KINGS BRANCH SUBDIVISION, PHASE TWO

APPLICATION NUMBER 9 DATE August 6, 2009

APPLICANT King Branch Subdivision, Phase Two

REQUEST Subdivision

DETAIL SITE PLAN

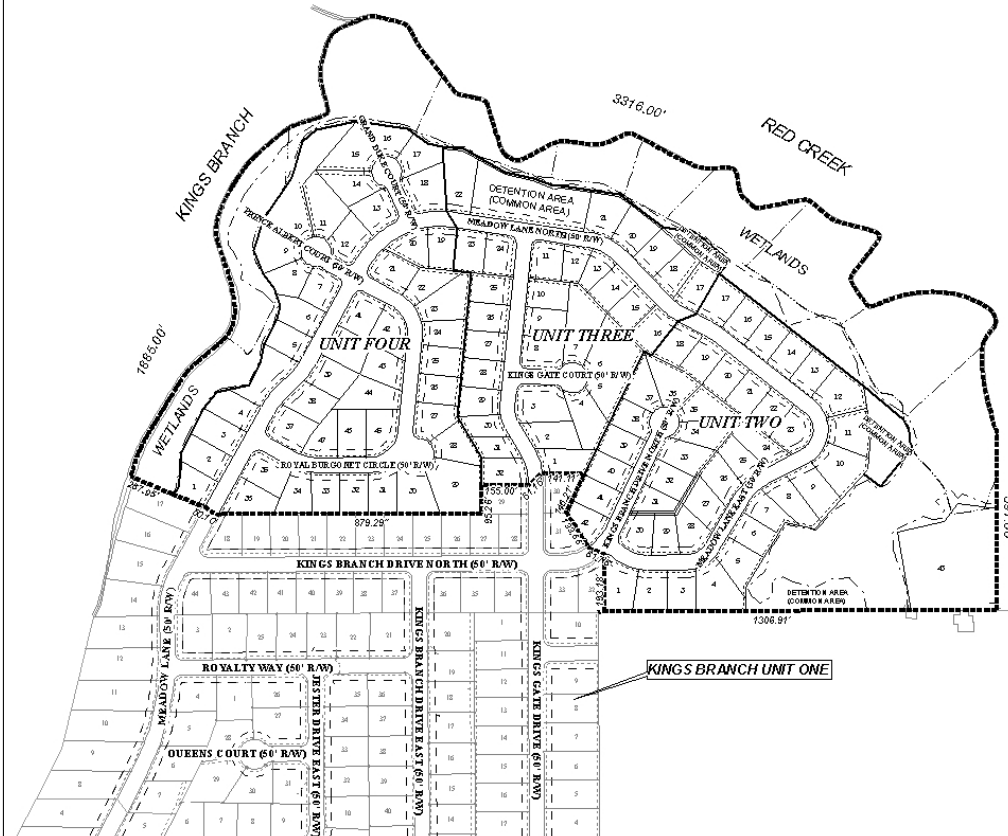
As proposed, Lots 35-37 in Unit Two, Lots 5-6 in Unit Three, and Lots 8-11, 28 in Unit Four have less than 60' of frontage, on which the building setback lines are illustrated at 25'. Section V.D.2 of the Subdivision Regulations states that lots shall be a minimum 60' in width at the building setback line. Therefore, the applicant should revise the plat accordingly.

The plat meets the minimum size requirement for developments with access to public water and sewer. However, it is requested that the applicant revise the preliminary plat to label each lot with its size in square feet, or provide a table on the plat with the same information.

The northern portion of the site lies within a flood zone and contains associated wetlands, which is labeled as common area for the subdivision. Also, four additional common / detention areas are illustrated on the plat. As illustrated on the plat, all common areas will be accessed either directly from a proposed public street or via ingress / egress easements. The applicant should place a note on the final plat stating that the maintenance of all common areas will be the responsibility of the property owners and that no building construction is allowed within easements.

- 1) the construction and dedication of the new streets to County Engineering standards and acceptance by County Engineering prior to signing the final plat;
- 2) placement of a note on the final plat stating that all lots, including corner lots, are limited to one curb cut each, with the size, location, and design to be approved by County Engineering and conform to AASHTO standards;
- 3) revision of the front setback line on Lots 35-37 in Unit Two, Lots 5-6 in Unit Three, and Lots 8-11, 28 in Unit Four to where these lots are at least 60' in width, in accordance with Section V.D.2 of the Subdivision Regulations;
- 4) labeling of each lot with its size in square feet, or the provision a table on the plat with the same information;

- 5) placement of a note on the final plat stating that the maintenance of all common areas will be the responsibility of property owners;
- 6) placement of a note on the final plat stating that no construction is allowed within easements, detention areas, or wetlands;
